AMENDMENT OF SOLICITATION/MODIFICATION OF CONTRACT ST. MARY'S COLLEGE OF MARYLAND			PAGE 1 OF PAGES 4	
1. AMENDMENT/MODIFICATION NO. 01	2. EFFECTIVE DATE: November 13, 2023	3. REQUISITION NO	4A. TITLE Tennis Complex Renovation	4B. PROJECT

RFP No. SMC-24-40264

Tennis Complex RFI Q&A Response

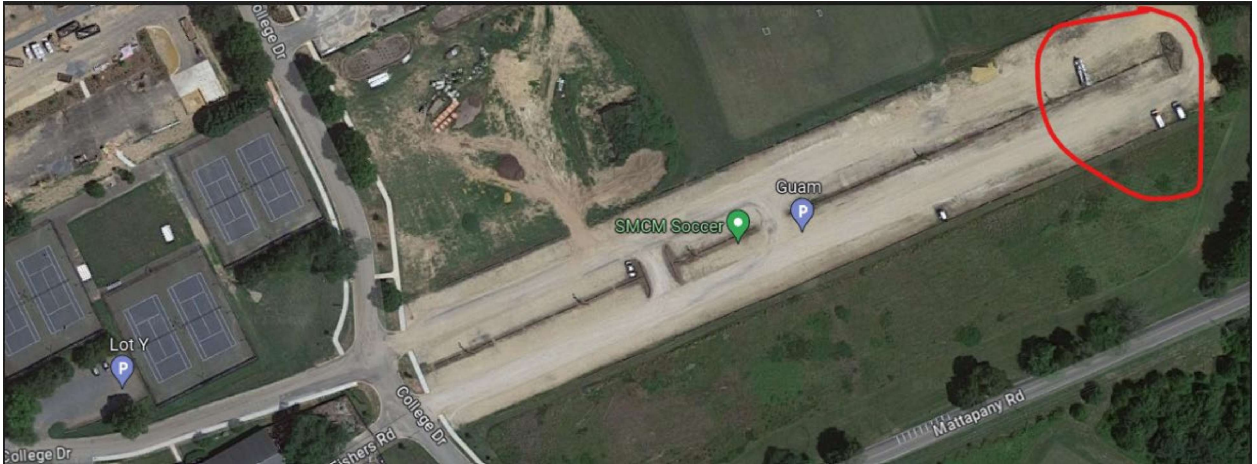
6. Notes indicate “pulverizing and reclaiming existing asphalt for reuse.” Our asphalt contractors do not recommend using this product as a subbase immediately below the new hot mixed asphalt as you cannot get the proper compaction and the subbase is likely to move as you pave over with the new material due to the introduction of heat.

Answer: It is ultimately up to the Contractor’s means and methods to reconstruct the existing tennis courts, achieve proper compaction of base material as required for paving and court surfacing. We take no exception with the removal of existing materials and replacing with all new materials. The intent of the Contract Documents was a full-depth reclamation (asphalt and base material, 10” min) and the ability to supplement with additional new crushed base material as needed to laser grade and achieve proper compaction per MDSHA. A new binder course and surface course would be installed over the properly compacted base material.
